A 17981

SEWAGE DISPOSAL TESTING

STATE OF MARYLAND - DEPARTMENT OF HEALTH AND MENTAL HYGIENE

SUBDIVISION Breezewood Farms LOT NO. 16, Sect. 4

BREEZEWOOD FARM

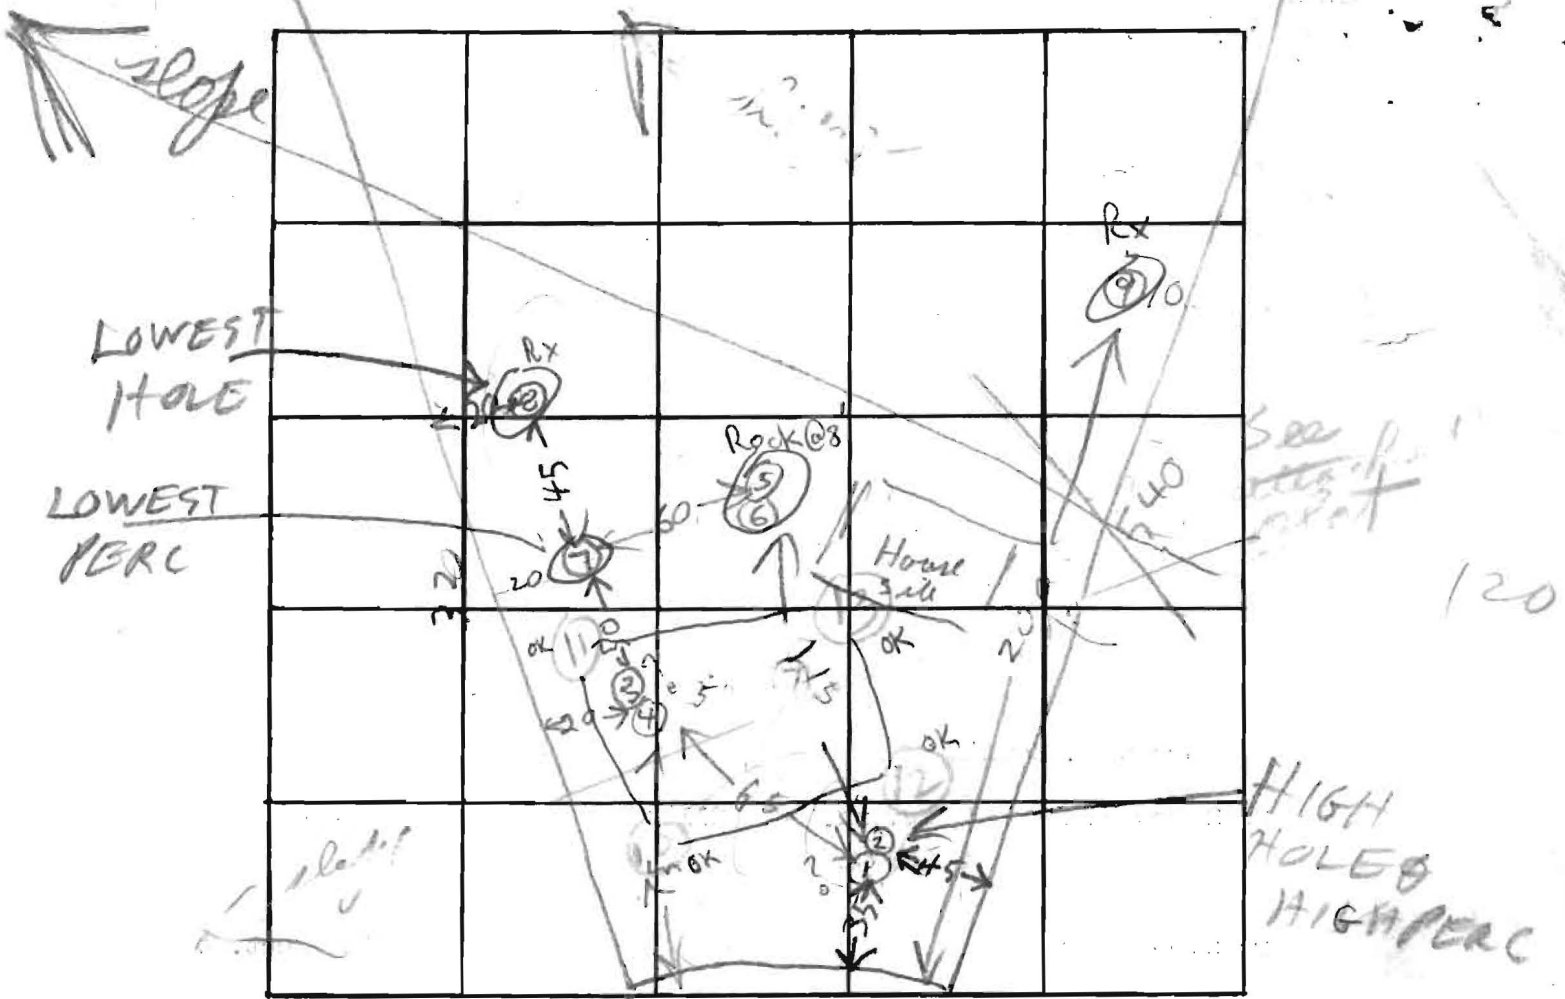
8/14/79 Rejected

- ① Show sewage disposal area & well on adjacent lots
- ② Show elevation of house site & well sites
- ③ Must state that perc holes are field located

8/29/79 DM said get elevation of Wells

^{0V00} Elevation for the Lot 16 But would like to submit a less precise elevation for wells on adjacent lots since it doesn't matter whether or not those wells are higher or lower than the septic system on lot 16 also Told Mr Crovo

8/29/79 - Told Mr Crovo
That The penciled lines & letter
must be changed to ink RM
Some one picked up plat

Discussed above with Chuck Crovo He will make corrections R18

8/29/79 Revised Plat OIC for Health Officer to sign R18

He is going to submit an accurate
